PROPOSED \$4.55 CHANGE LIST

Project Name
Castlecrag Quadrangle

Drawing Title
BASEMENT 02 PLAN

Drawing No
A10-0800

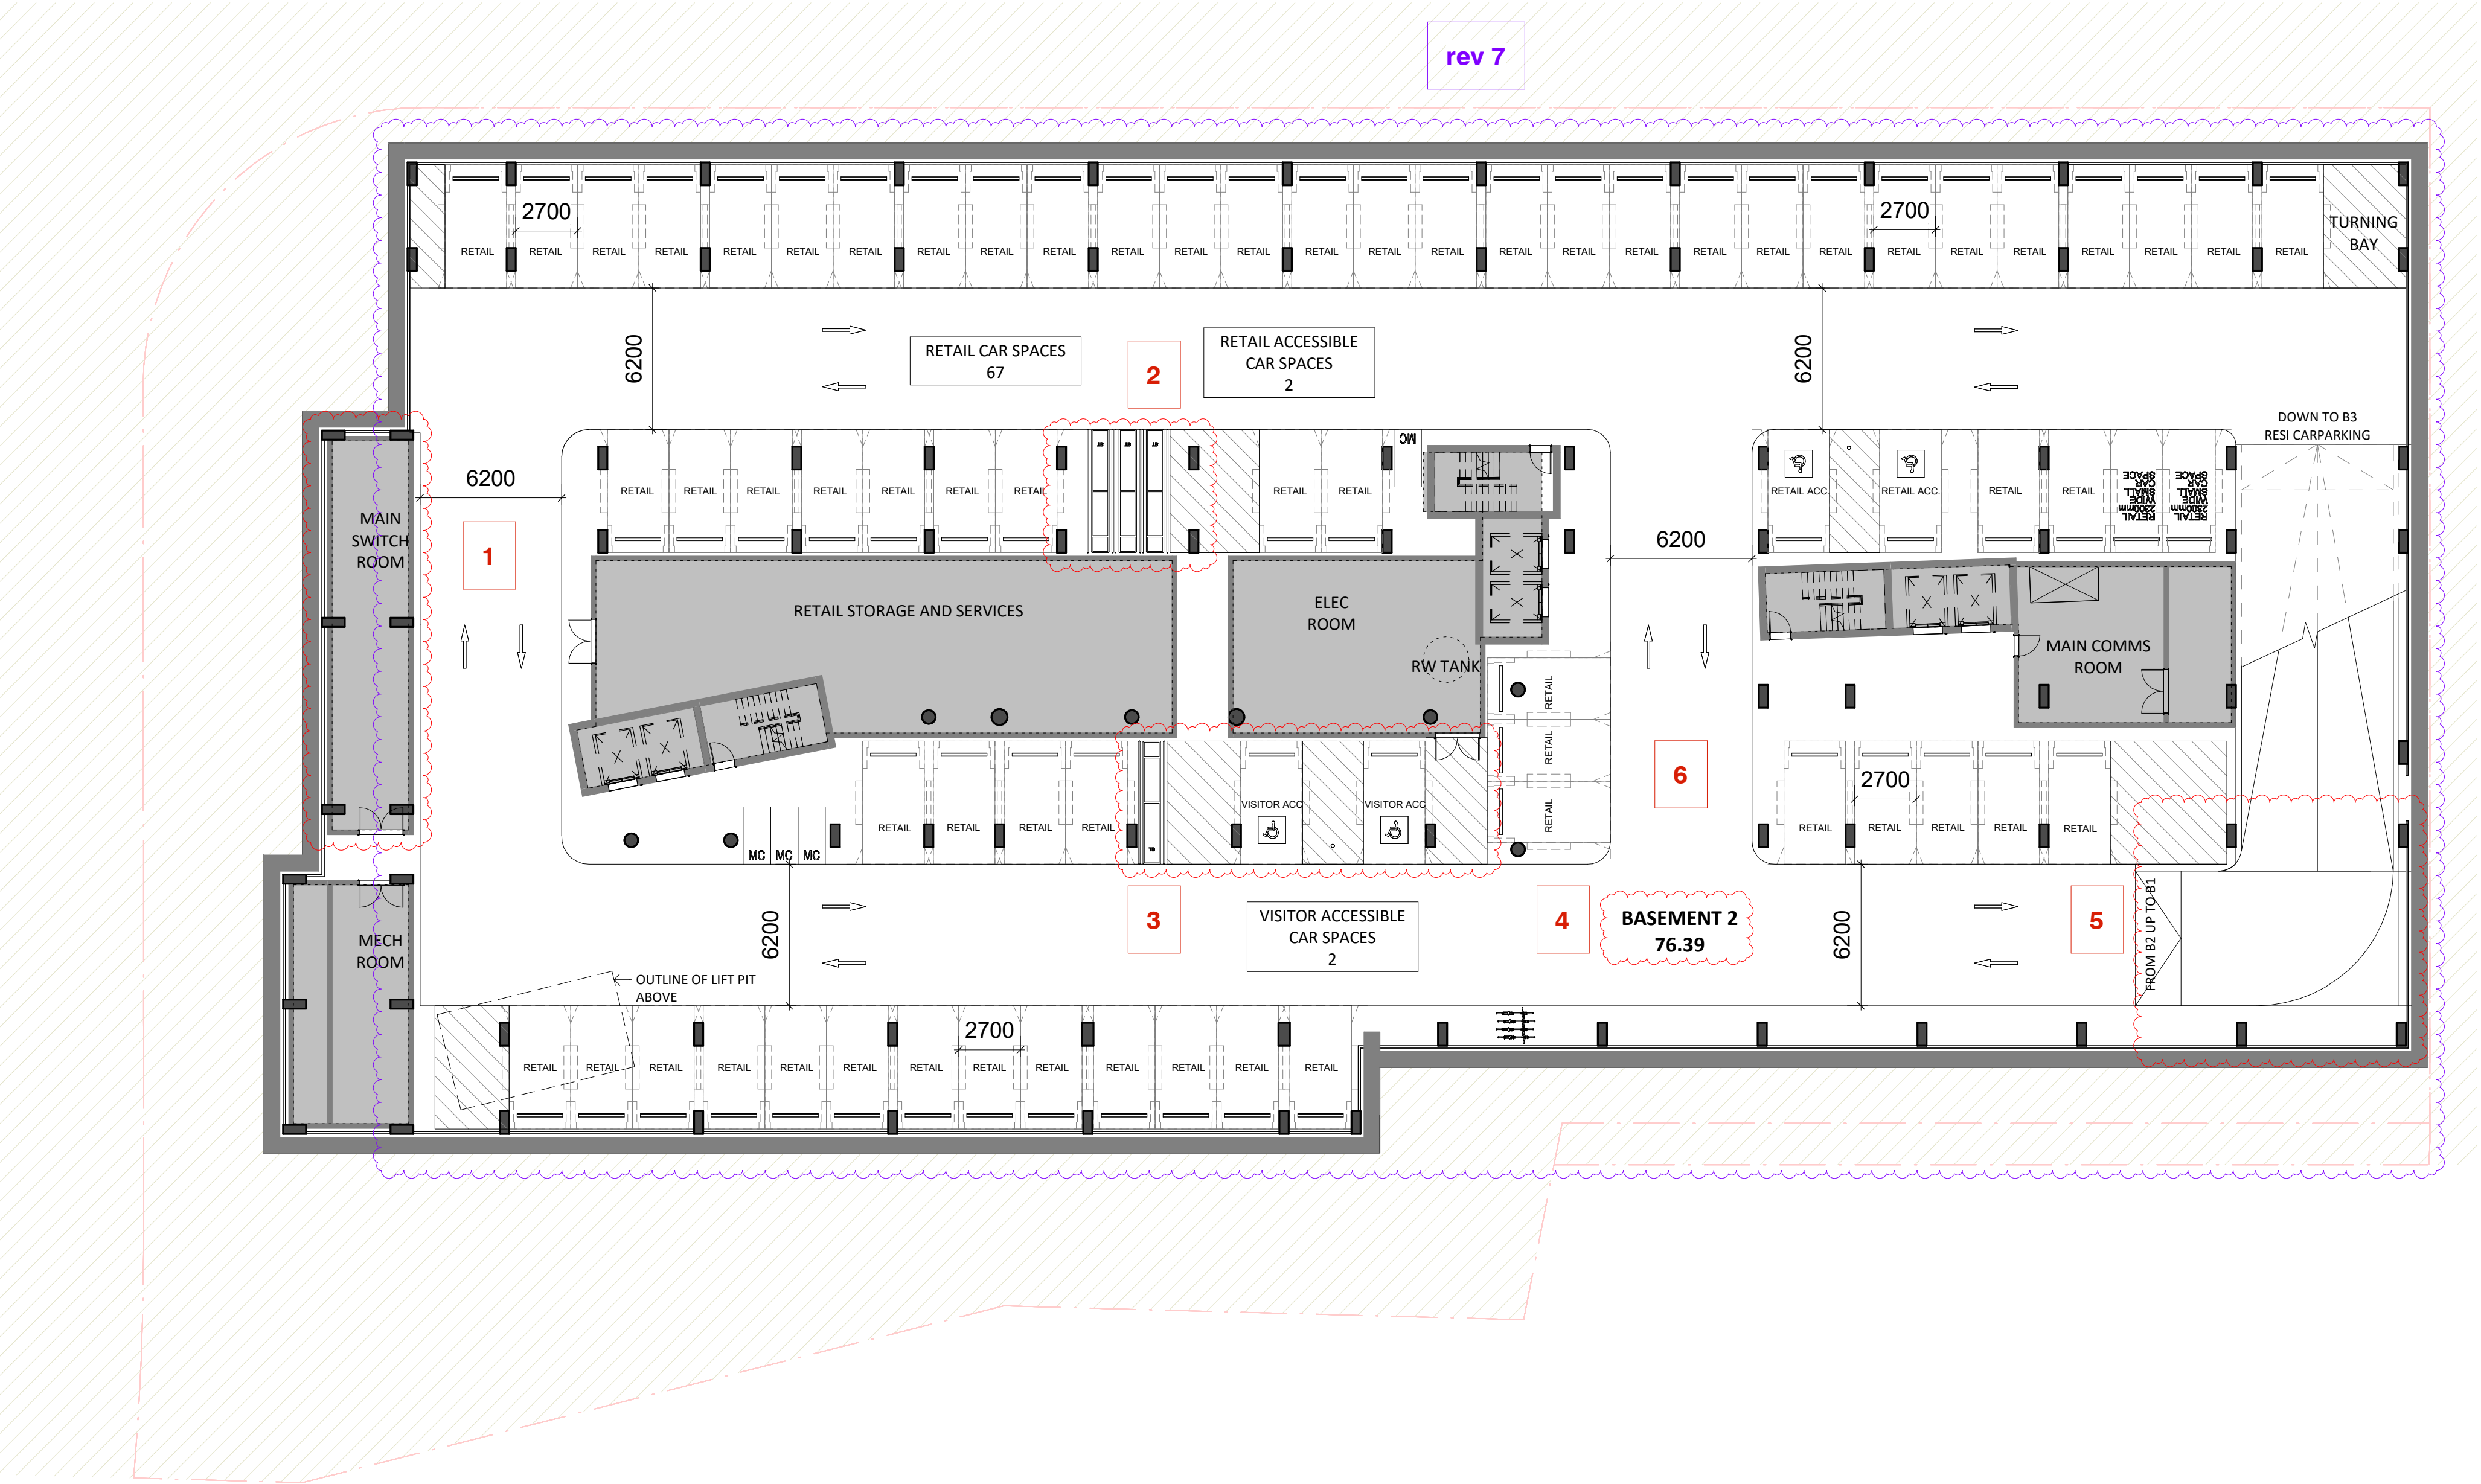
1. PARKING MOVED FROM HERE TO MAKE ROOM FOR THE MAIN SWITCH ROOM
2. TROLLEY BAYS INCLUDED HERE, AND ACCESSIBLE VISITOR PARKING SPACES MOVED HERE FROM LB1
4. LOWERING THE SLAB LEVEL OF THE DA APPROVED BASEMENT 2 TO IMPROVE OPERATIONAL EFFICIENCY, FUNCTIONALITY AND DURABILITY FOR USERS.
5. RAMP DOWN FROM LB1 INCREASED TO ACCOMMODATE THE LOWERED BASEMENT LEVEL.
6. COLUMNS INCLUDED AFTER INITIAL CO-ORDINATION WITH THE STRUCTURAL ENGINEER. BASEMENT PERIMETER COLUMNS NEEDED.
